Project	IEEE 802.16 Broadband Wireless Access Working Group < http://ieee802.org/16 >	
Title	Primitives Supporting Association Procedures	
Date Submitted	2007-01-18	
Source(s)	Ronald Mao	Voice: 858-882-0335 Fax: 858-882-0350 rmao@huawei.com
Re:	P80216g_D6	
Abstract	This contribution proposes C_SAP primitives to be adopted in IEEE 802.16g to support association procedures specified in IEEE 802.16e-2005.	
Purpose	Adopt the contribution.	
Notice	This document has been prepared to assist IEEE 802.16. It is offered as a basis for discussion and is not binding on the contributing individual(s) or organization(s). The material in this document is subject to change in form and content after further study. The contributor(s) reserve(s) the right to add, amend or withdraw material contained herein.	
Release	The contributor grants a free, irrevocable license to the IEEE to incorporate material contained in this contribution, and any modifications thereof, in the creation of an IEEE Standards publication; to copyright in the IEEE's name any IEEE Standards publication even though it may include portions of this contribution; and at the IEEE's sole discretion to permit others to reproduce in who

Figure 0-1 Primitives for association ranging report

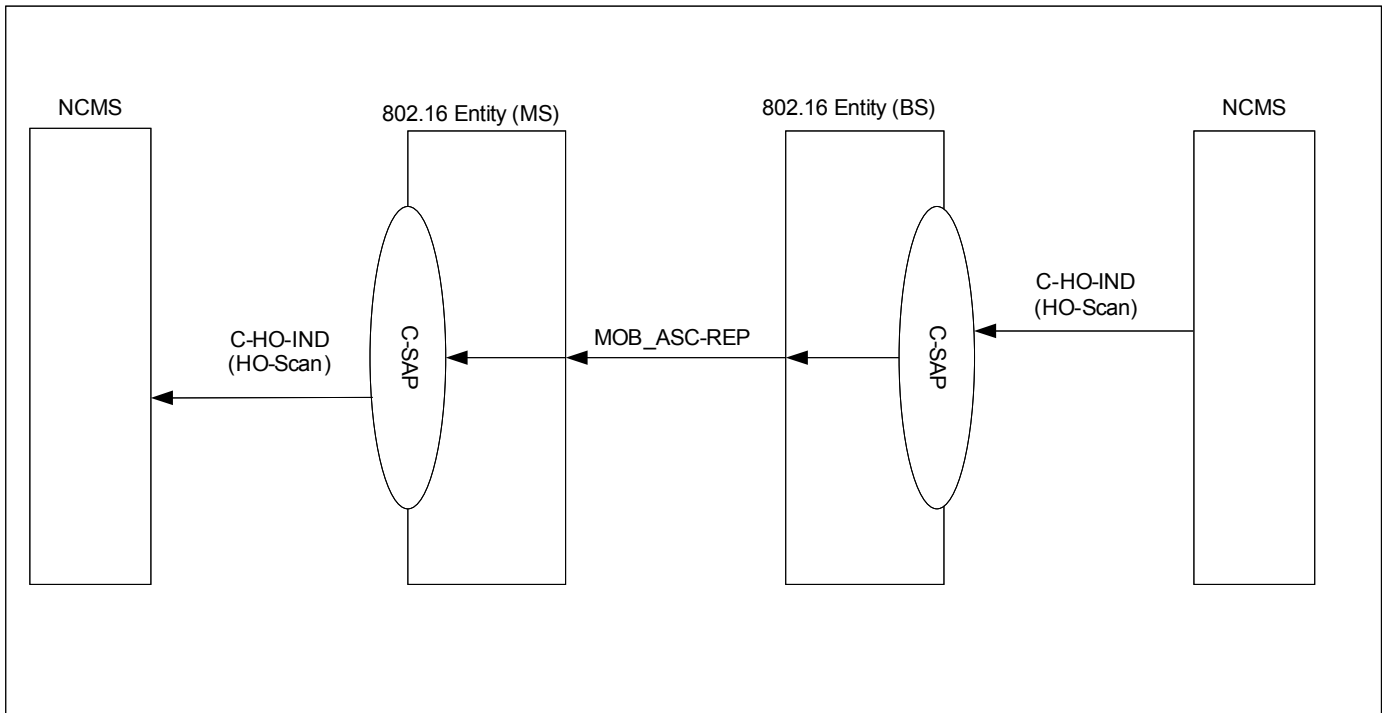
[Insert this diagram after Figure 493 on Page 78]
